Converting from 93xx46 Devices to 93xx46A/B Devices

AN664

PRODUCT CONVERSION DECISION TREE

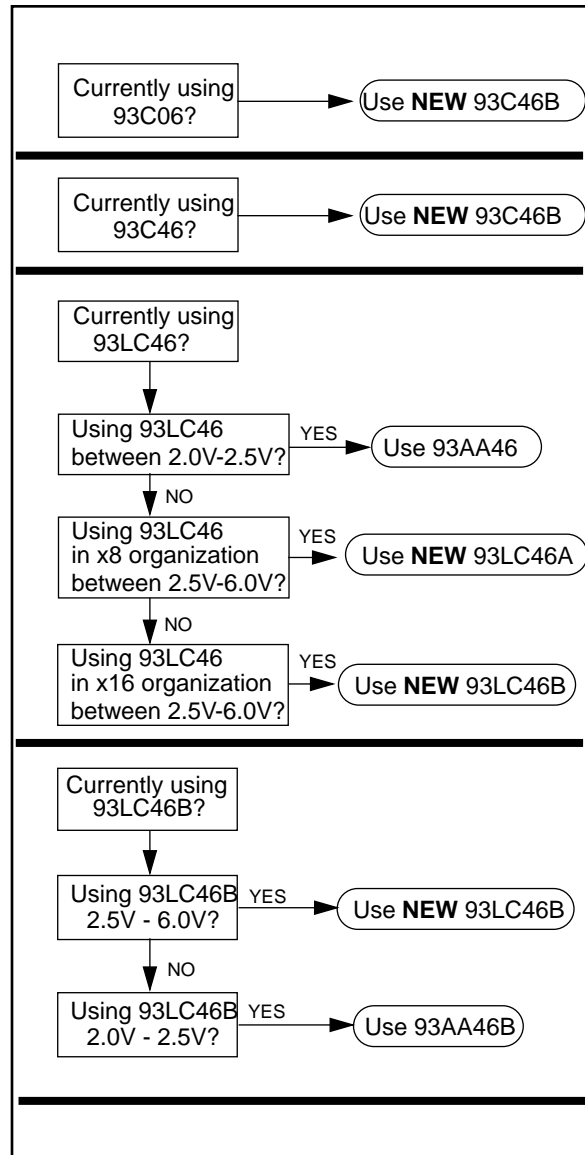
The following product conversion decision tree will assist in converting to the new 93xx46A/B products. In order to properly convert to new products two items need to be known about the existing application, the operating voltage of the system and whether the memory is organized as x8 or x16. Once that information is known then the decision tree will assist in determining what the new product should be. The product selection is also available in tabular form on page 2.

Part number currently being used	Voltage Range	Organization	New part number to be used
93C06	All	All	NEW 93C46B
93C46	All	All	NEW 93C46B
93LC46	2.5V - 6.0V	x8	NEW 93LC46A
93LC46	2.5V - 6.0V	x16	NEW 93LC46B
93LC46	2.0V - 2.5V	All	93AA46
93LC46B	2.5V - 6.0V	All	NEW 93LC46B
93LC46B	2.0V - 6.0V	All	93AA46B

VOLTAGE OPERATION GRAPHS

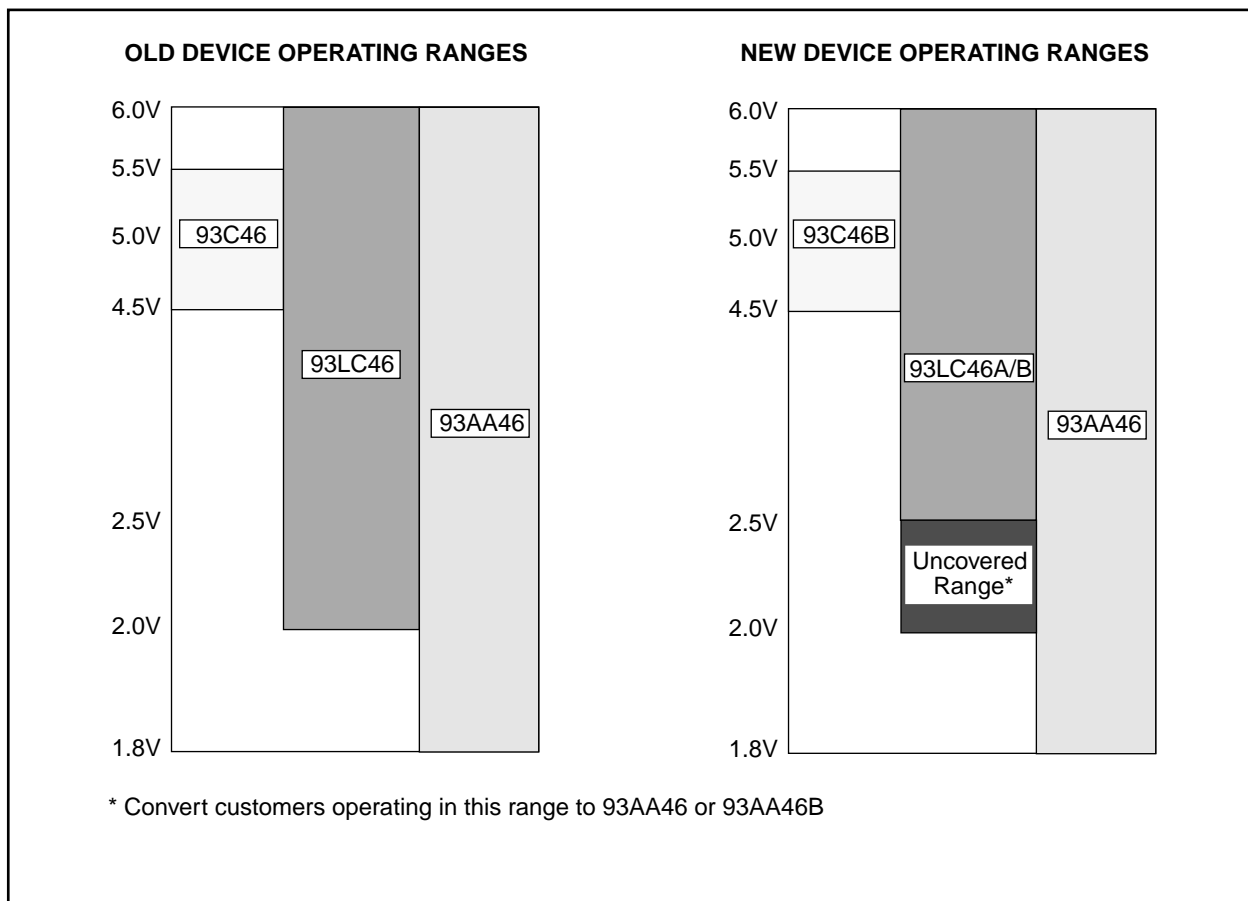
The following two graphs show the operating voltages of the current 93xx46 devices and the **NEW** 93xx46A/B devices. From the graphs it can be seen that there is a voltage range covered by the existing devices that is not covered by the new devices. The continued production of the 93AA46 device ensures that anyone currently operating in the voltage range not covered by the new 93xx46A/B devices will have a conversion solution.
